P 534463

## Septic Repair ON-SITE SEWAGE DISPOSAL SYSTEM HOWARD COUNTY HEALTH DEPARTMENT BUREAU OF ENVIRONMENTAL HEALTH

SUBDIVISION: Rix Property LOT NUMBER: \_\_\_\_\_

ADDRESS: 944 Hoods Mill Road PROPERTY OWNER: Justin and Jennifer Rix

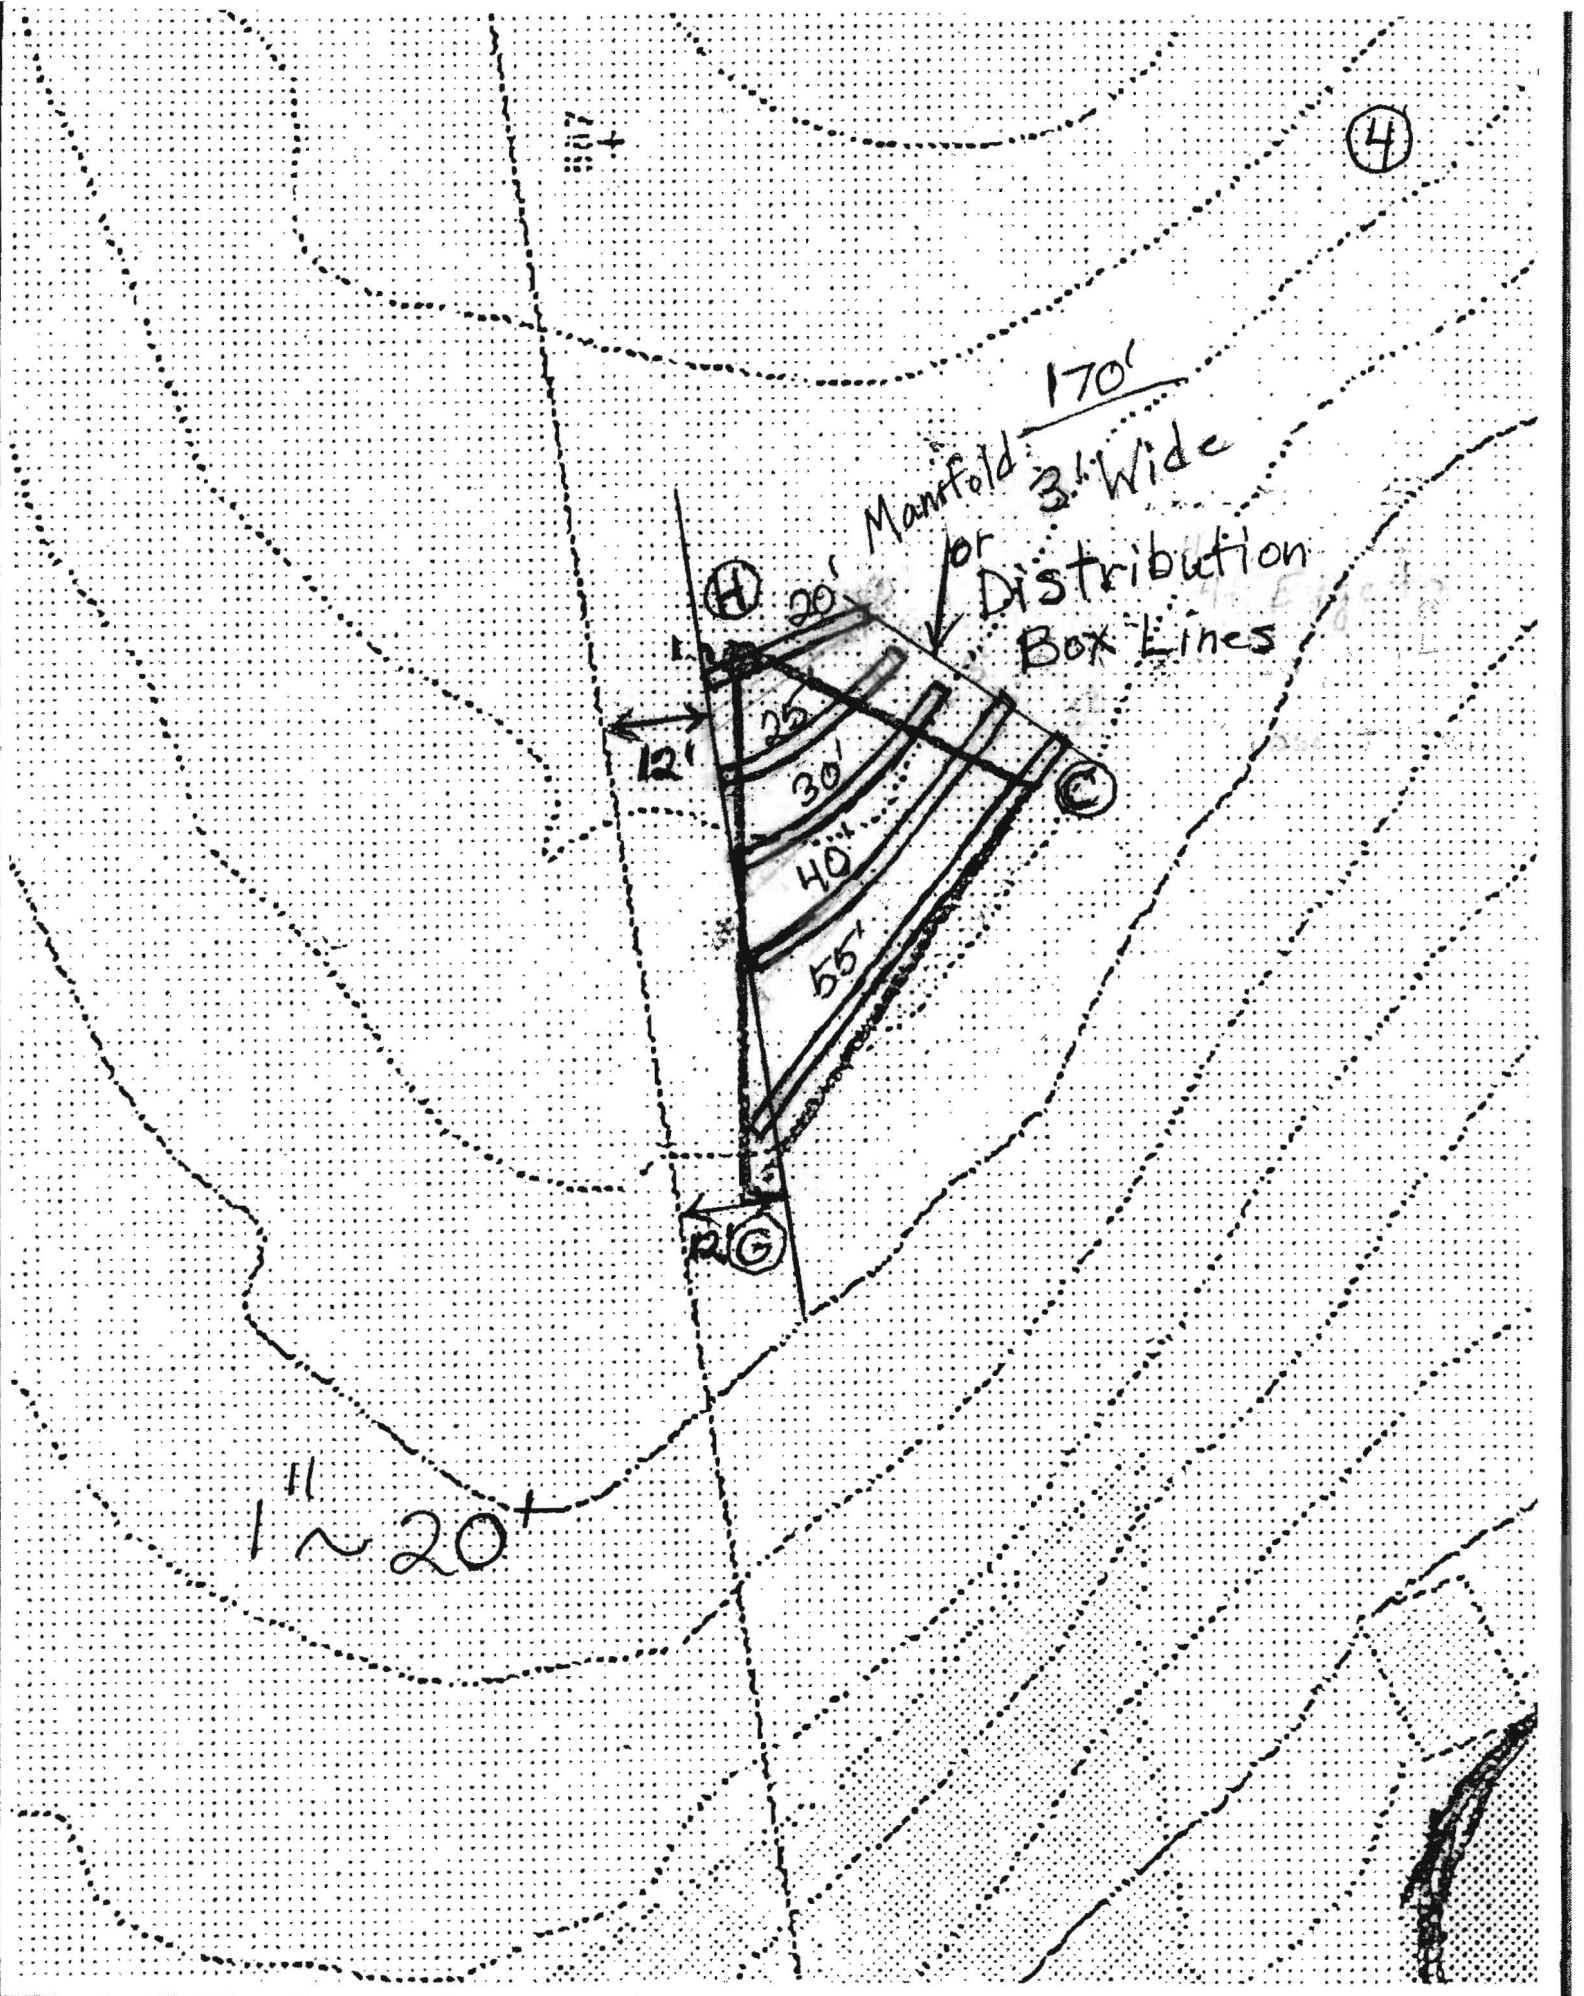
Bill/Justin - I see two options. Either three 9' Wide Beds or 3' Trenches Spaced Close Together

LPD is required for beds. I may however use gravity with the trenches if you can get fall to a 2' inlet at the highest trench. To get fall to trenches they would probably have to have a hung sewer or some kind of pump. Either way pretreatment will be required due to limited repair area. Any future repairs would most likely be near or above grade. A drip system should work. Less likely but still a possibility would be a sand mound or an at-grade system. Further perc testing with passing results would be required for one of these systems. They all require a pumped system and the drip and mound systems are expensive.

Trenches: Low Pressure Dosing

3' Wide Trenches That Will Be About 4' Apart at the Closest Points  $\sim 170'$  Total

20' Trench - Inlet 2.5' and Bottom 8'

25' Trench - Inlet 2.5' and Bottom at 7.5'

30' Trench - Inlet 3' and Bottom at 7'

40' Trench - Inlet 3.5' and Bottom at 6.5'

55' Trench - Inlet 4' and Bottom at 6'

Trench System - Gravity Distribution

3' Wide Trenches that Will Be About 4' Apart at the Closest Points

20' Trench - Inlet 2' and Bottom at 8'

25' Trench - Inlet 2' and Bottom at 7.5'

30' Trench - Inlet 2' and Bottom at 7'

40' Trench - Inlet 2' and Bottom at 6.5'

55' Trench - Inlet 2' and Bottom at 6'

I'm Raising the Gravel Depth in Order to Try to Get Some Air to the Trenches Since They Aren't LPD

Included Are Some Drawings Showing Hypothetical Trench and Bed Layouts - Hopefully They Are Close

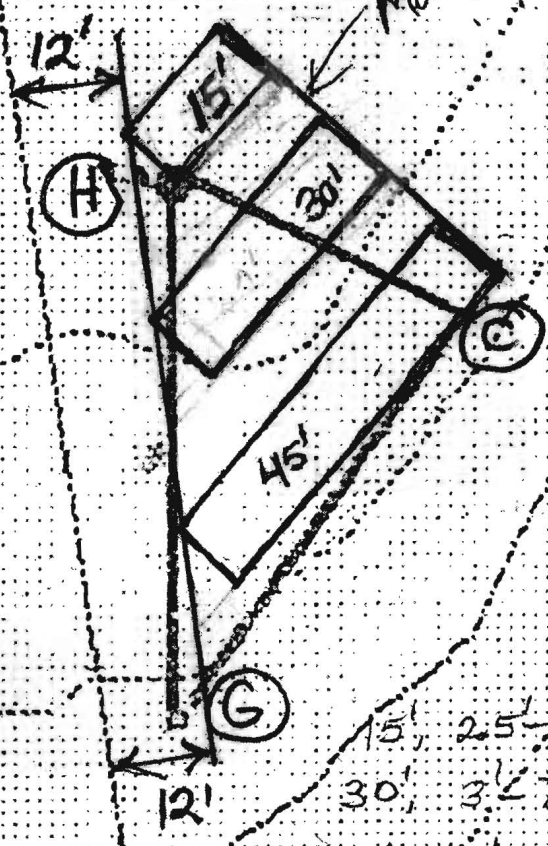
### Beds:

9' Wide With Lengths of 15', 30' and 45'.

15' Bed - Inlet 2.5' and Bottom at 8'

30' Bed - Inlet 3' and Bottom at 7'

45' Bed - Inlet at 3.5' and Bottom at 6'

15', 2.5'-8'  
 30', 3'-7'  
 45', 3.5'-6'
